Arizona Department of Transportation

MEMORANDUM

Subject: C-Standards Update

Construction Standard Drawings Revisions – April 2006

APPROVED FOR DESIGN <i>Mary Viparina</i>	STATE OF ARIZONA DEPARTMENT OF TRANSPORTATION ROADWAY STANDARD DRAWINGS	REV. 4/06
APPROVED FOR DISTRIBUTION <i>John [Signature]</i>	CONCRETE HALF-BARRIER TRANSITION TYPE 'F' TANGENT DEPARTURE TYPE 2	DRAWING NO. C-10.75 Sheet 2 of 2

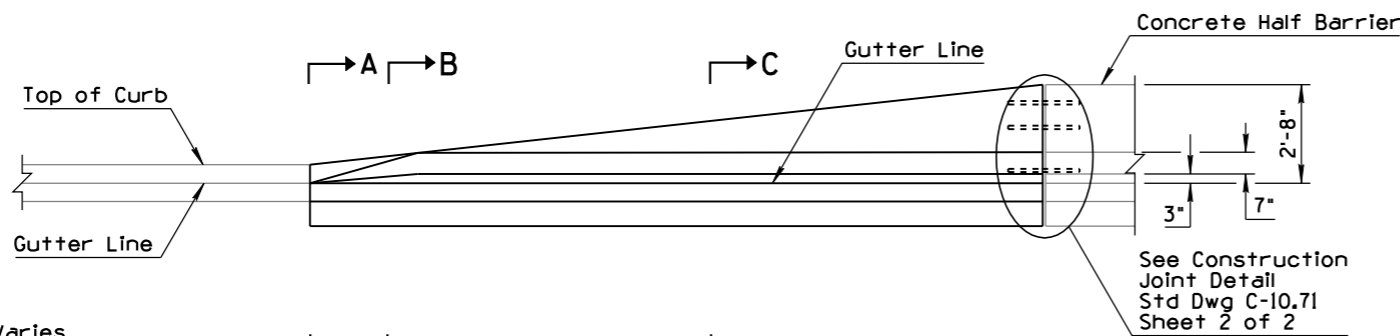
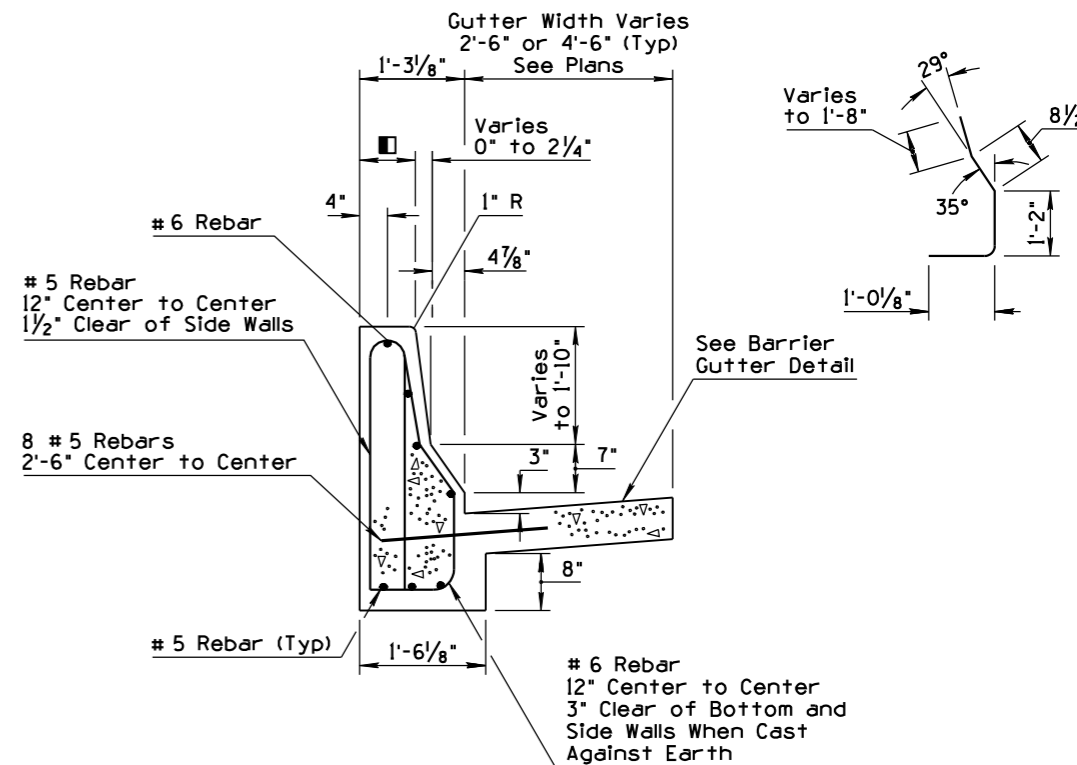
C-10.75, Sheet 1 of 2	Changed "PLAN VIEW" to "PLAN". Removed slope designation from sidewalk in SECTION views. Revised curb-height designation in SECTION A-A from "H" to "h".
C-10.75, Sheet 2 of 2	Changed "PLAN VIEW" to "PLAN". Removed dimensions at right side of PLAN view. Revised text orientation.
C-10.76	Changed "PLAN VIEW" to "PLAN". Revised SECTION view graphics to depict Type 'F' barrier.
C-10.77	Modified PLAN view to correct style and proportion of concrete half barrier and transitions. Modified references to other Std Dwgs.
C-11.10 Sheets 1 through 4 of 4	Re-issued Standard Drawing.
C-15.20, Sheet 1 of 3	Revised sheet number references.
C-15.91 & C-15.92, Sheet 2 of 2	Modified welding notations for ANSI conformance.
C-18.10, Sheet 2 of 3	Modified SECTION views to improve clarity.

NO	DESCRIPTION OF REVISIONS	MADE BY	DATE
1	REMOVED DIMENSIONS	RLF	4/06
2			
3			
4

APPROVED FOR DESIGN <i>May Vipavina</i>	STATE OF ARIZONA DEPARTMENT OF TRANSPORTATION ROADWAY STANDARD DRAWINGS	REV. 4/06
APPROVED FOR DISTRIBUTION <i>Julio</i>	MANHOLE BASE DETAILS NORMAL INSTALLATION	DRAWING NO. ① C-18.10 Sheet 2 of 3

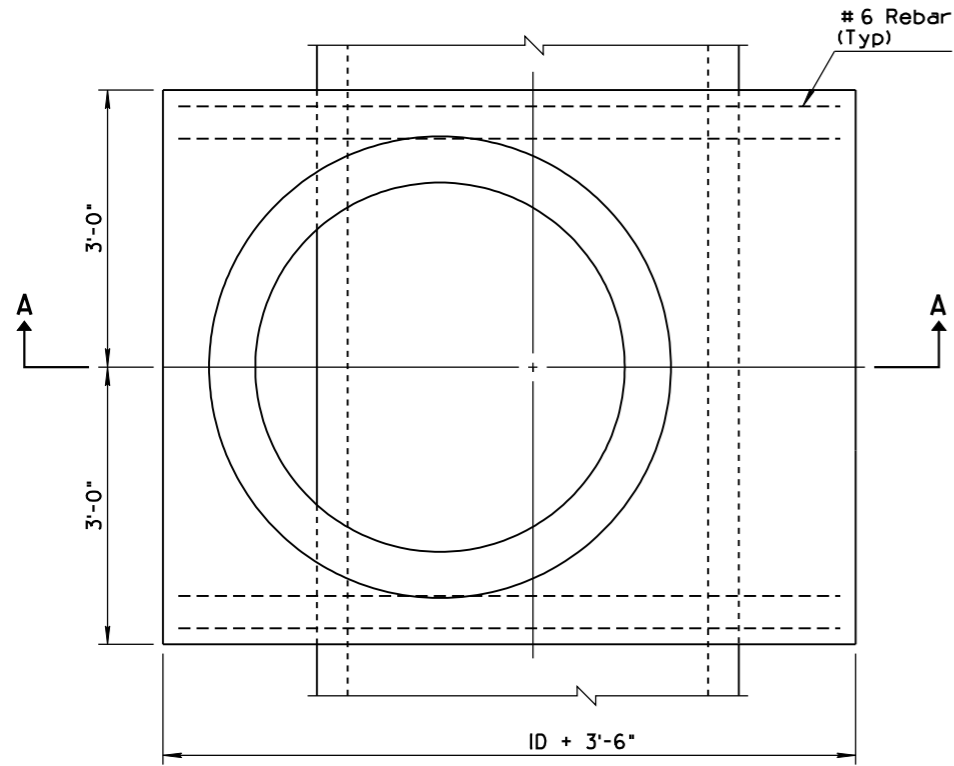
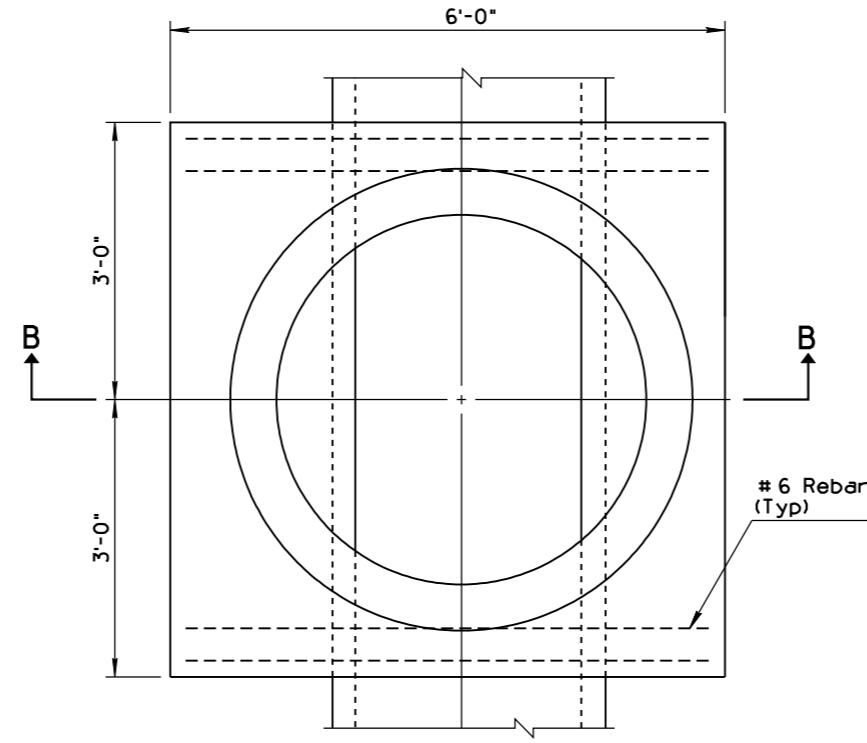
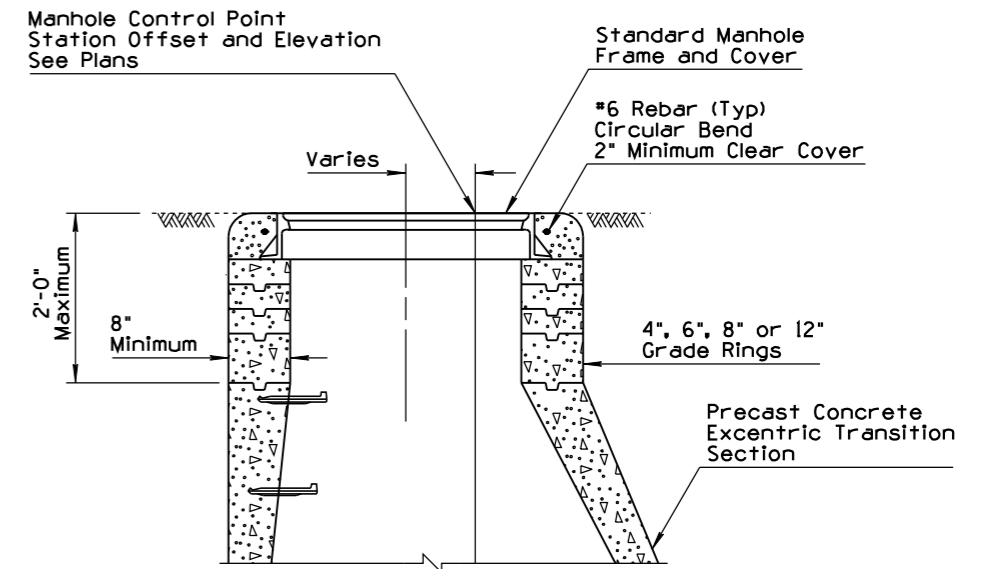
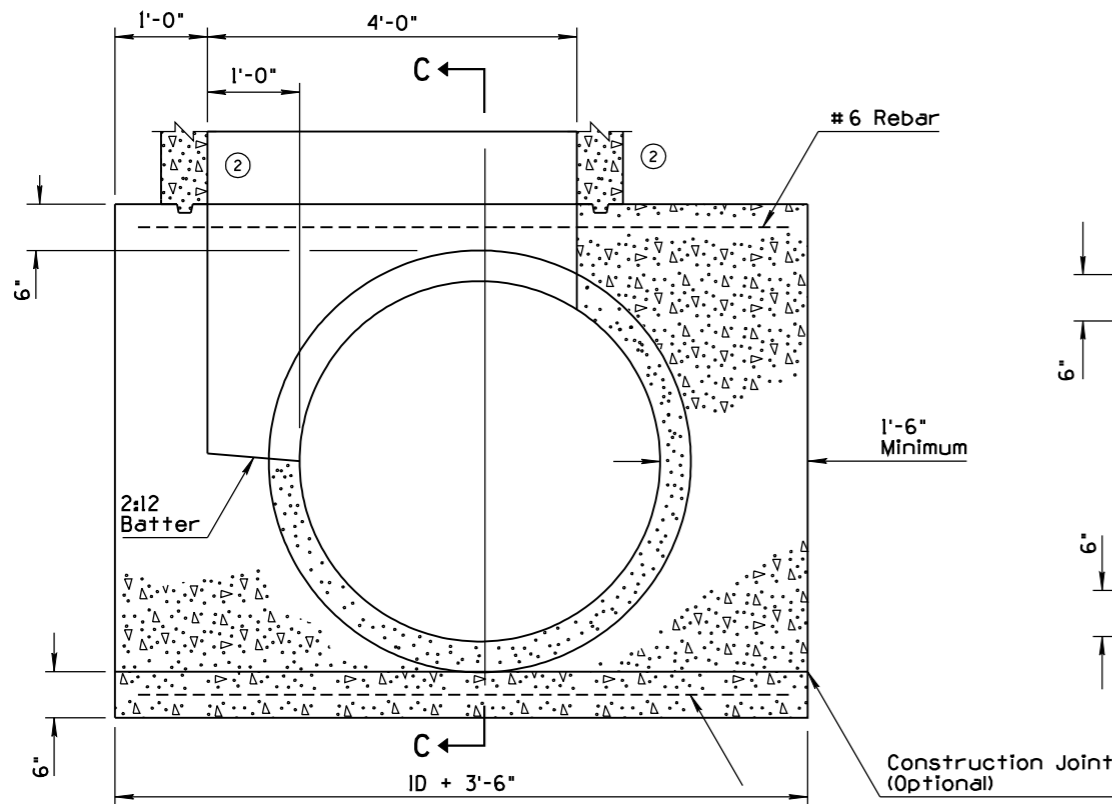
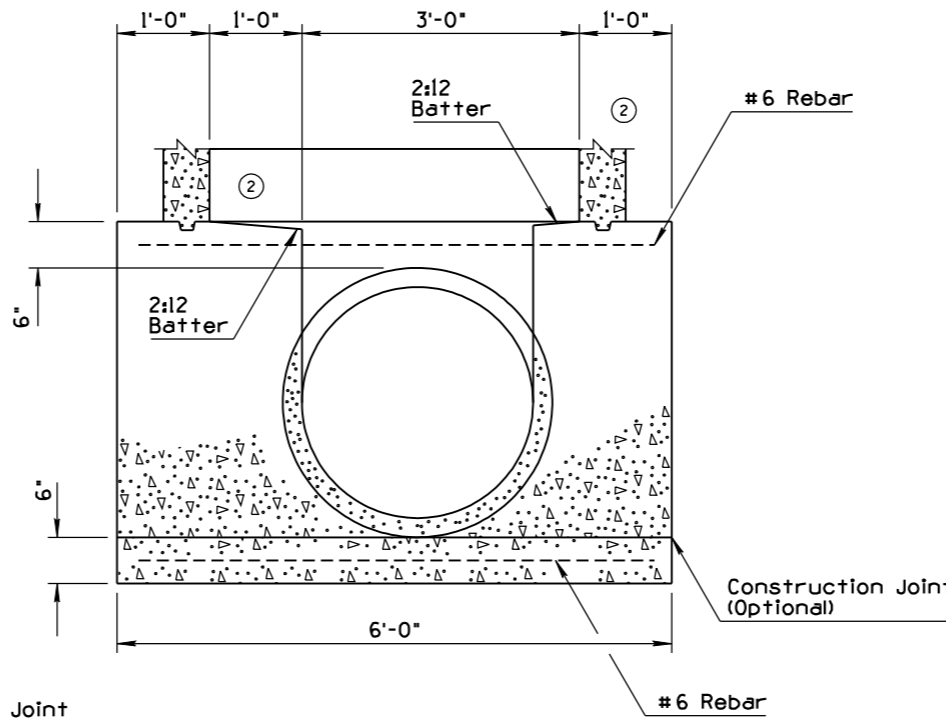
NO	DESCRIPTION OF REVISIONS	MADE BY	DATE
1	RENAMED STD DWG TO C-18.10, SHEET 2 OF 3	RLF	9/04
2	REVISED SECTION A-A THROUGH C-C GRAPHICS	RLF	4/06
3			
4
